TS/GK
15031
19 August 2016

**SECTION 75W MODIFICATION APPLICATION TO MAJOR PROJECT APPROVAL MP10_0219
1, 1A & 5 AVON ROAD, 4 & 8 BEECHWORTH ROAD, PYMBLE**

Figure 1 – Excerpt of plans, demonstrating typical apartment conversion
Source: Marchese Partners

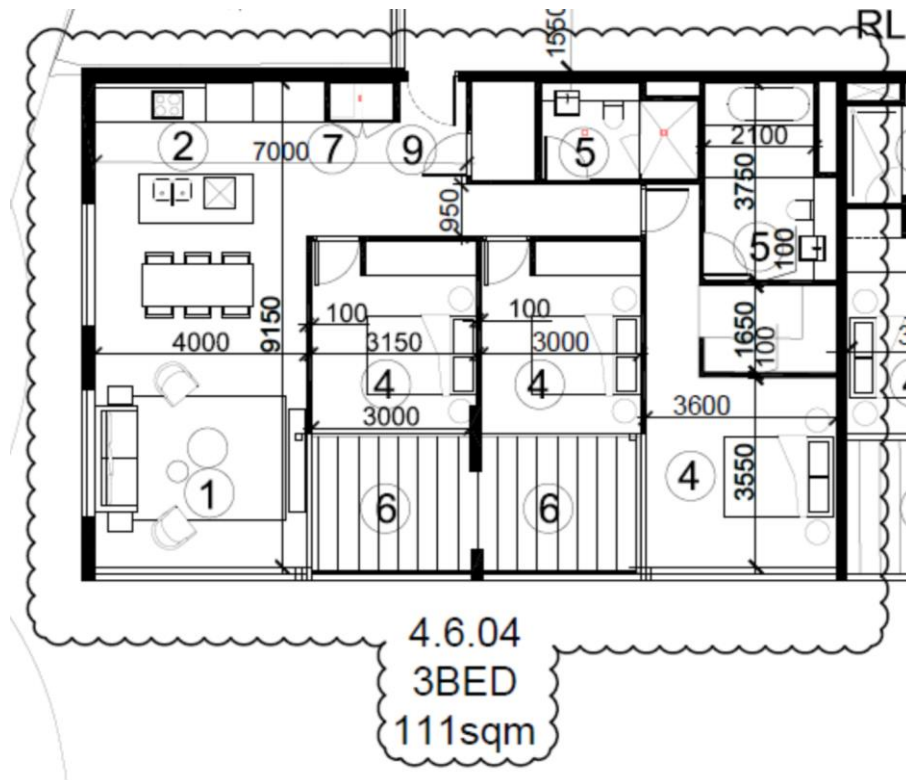
- **Conversion of Units** – A change in the mix of apartments in Building 4 has been proposed in order to better meet the needs of the market at the site. Apartment conversions have been scheduled at **Table 1** below, and an excerpt demonstrating the typical layout of unit conversion has been provided at **Figure 1**. As a result of the proposed unit conversion, the total number of units provided will be reduced from 174 units to 168 units. The new units have been designed to comply with the requirements of the Apartment Design Guide.

Figure 2 – Proposed revised layout at Level 1 of 1 Avon Road
Source: Marchese Partners

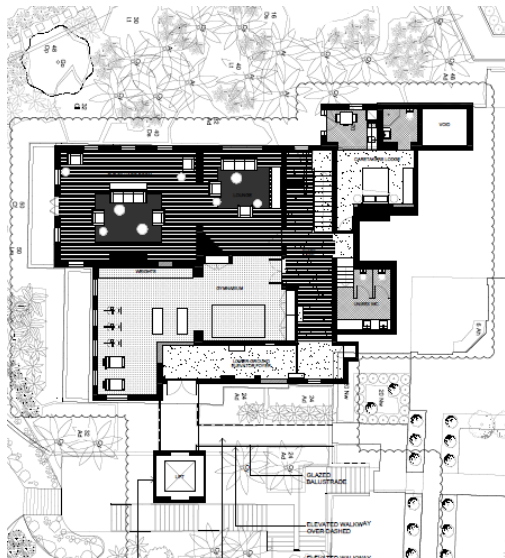
The proposed development includes changes to the lift access arrangements to the communal heritage building at 1 Avon Road. Namely, the proposal intends to remove the existing duplicated lift within the heritage building, and use minor design changes to connect the lower and upper floors of the communal building with the external lift to the east of 1 Avon Road. The revised layout has been depicted below at **Figure 2**.
